Hartland Township Planning Commission Meeting Agenda Memorandum

Subject: Site Plan Application #25-005 for a restaurant with pick-up window (Hartland Towne Square Planned Development)

Re: Hartland Towne Square Restaurant w/ Drive-through - Site Plan Review
SDA Review No. HL26-102

16 TRASH ENCLOSURE PLAN
SCALE: 1/4" = 1'-0"

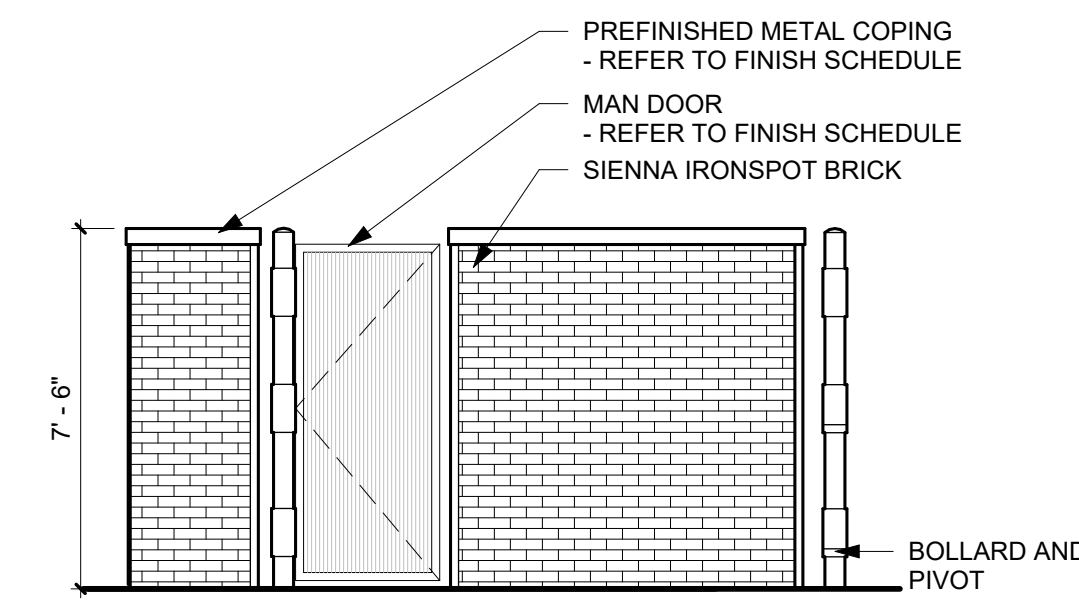
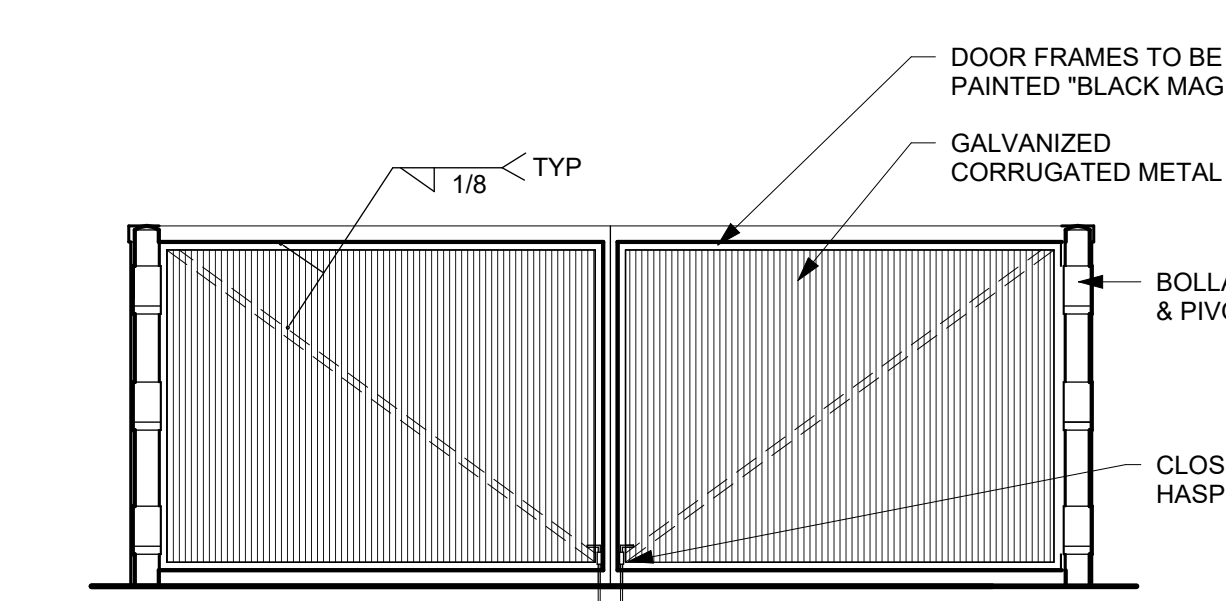
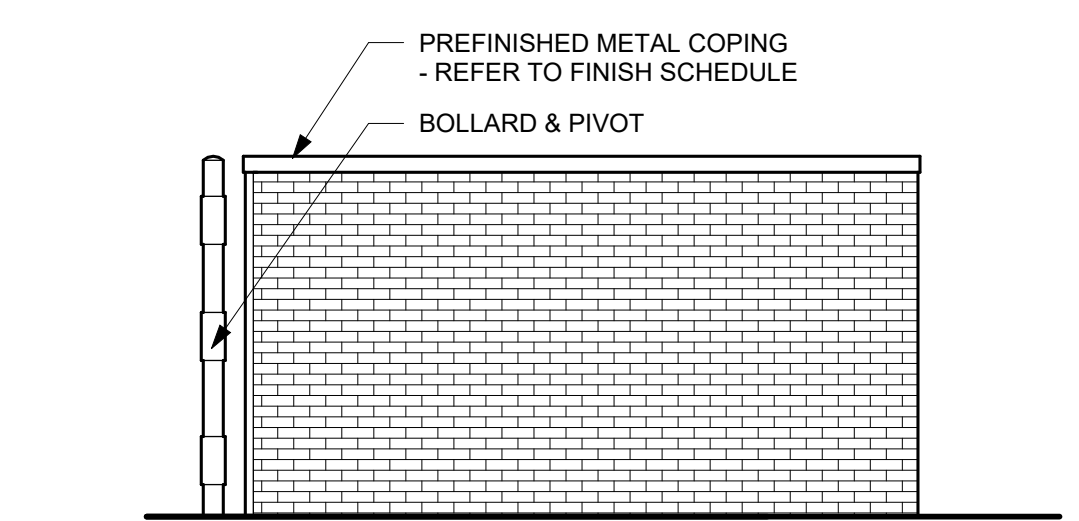
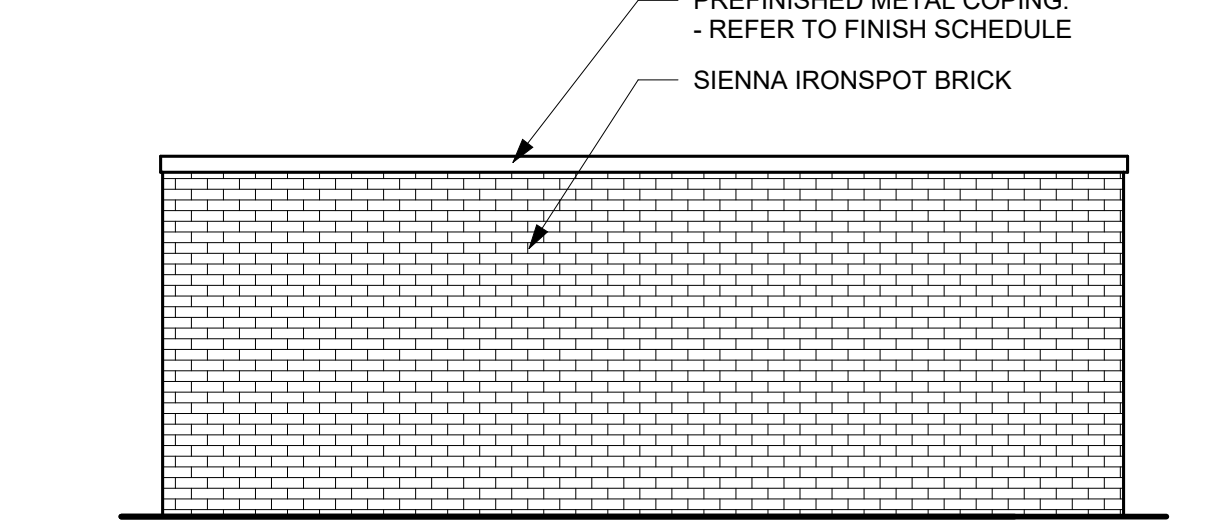
- Proposed – A screened refuse enclosure, with two stalls, is shown north of the building with a 7'6" high screen walls on three (3) sides. The screen walls are comprised of brick products that match the building. The enclosure doors are comprised of galvanized corrugated metal. The door color is not stated on the plans. The Pattern Book calls for solid frame doors but does not state specific products. Thirteen (13) evergreen trees are planted along the perimeter of the screen wall.

- Meets Requirements? – Yes
- Comments – The color of the metal doors should be stated on the Construction Plan set.

TITLE:
COVER SHEET

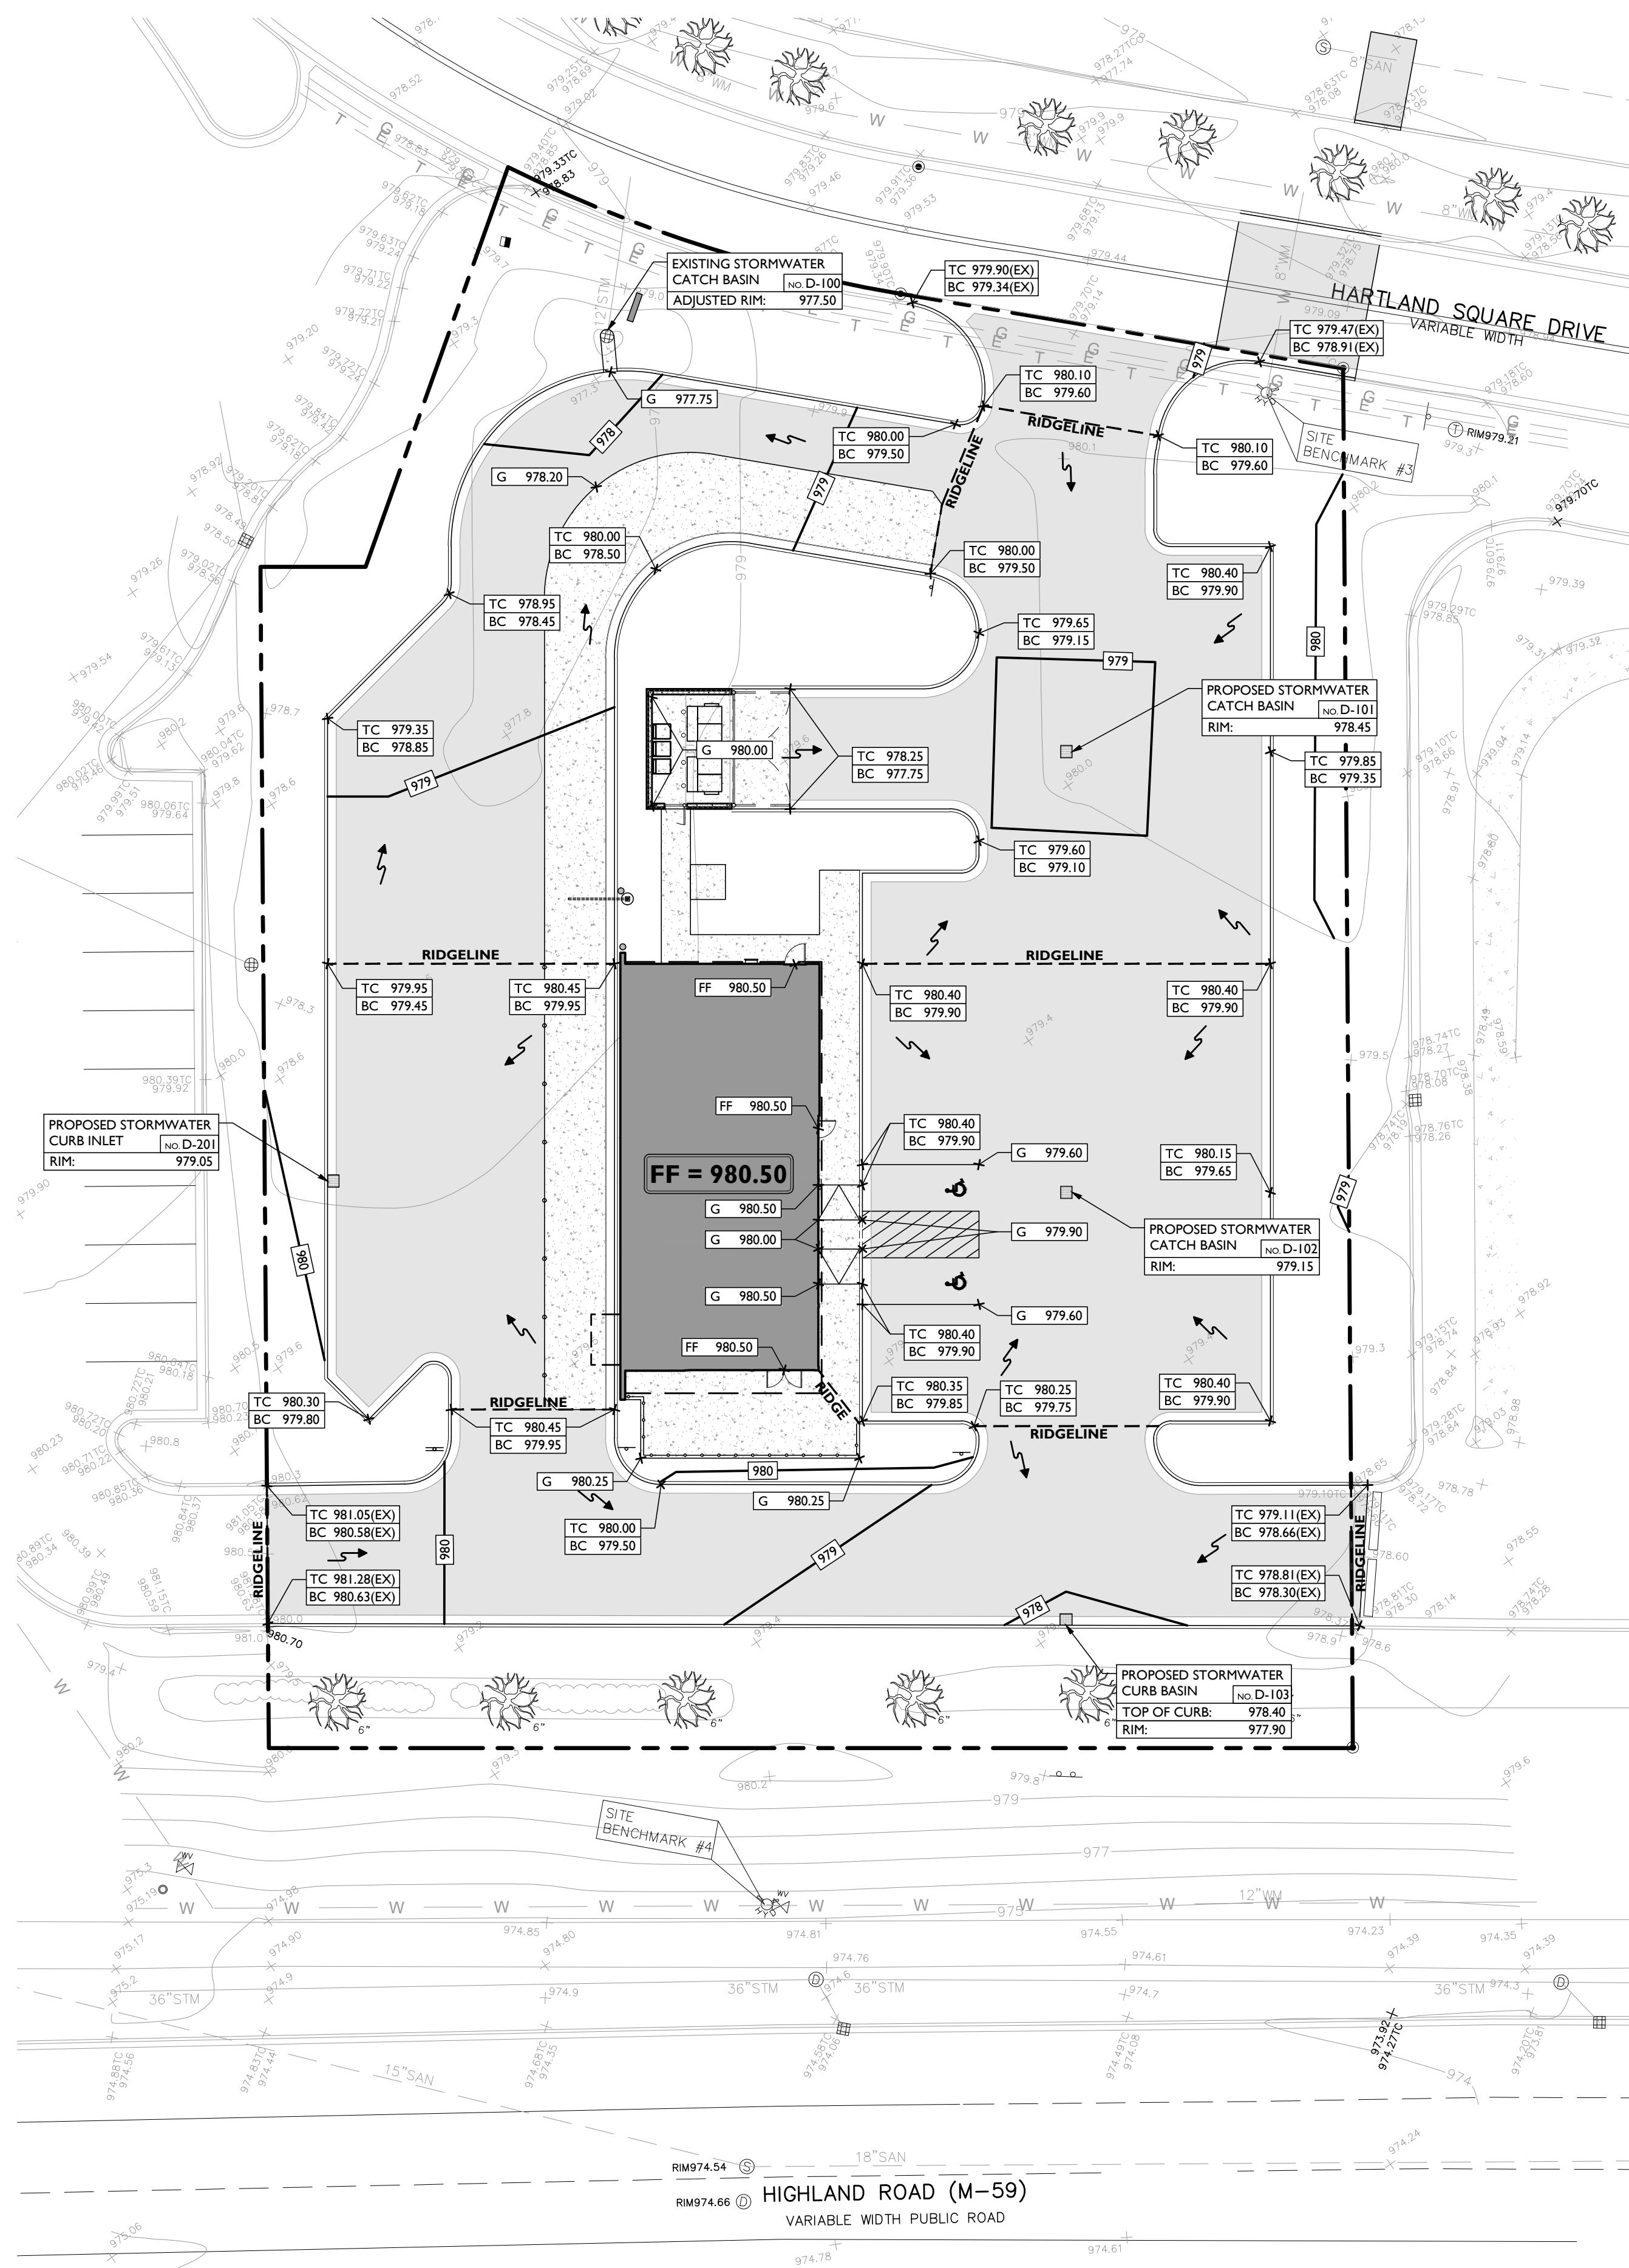
1. Provide standard detail sheets for both Livingston County and Hartland Township.
2. Address listed on cover sheet states 10540 Hartland Square Drive. However, this does not seem to align with Township records. Please clarify.
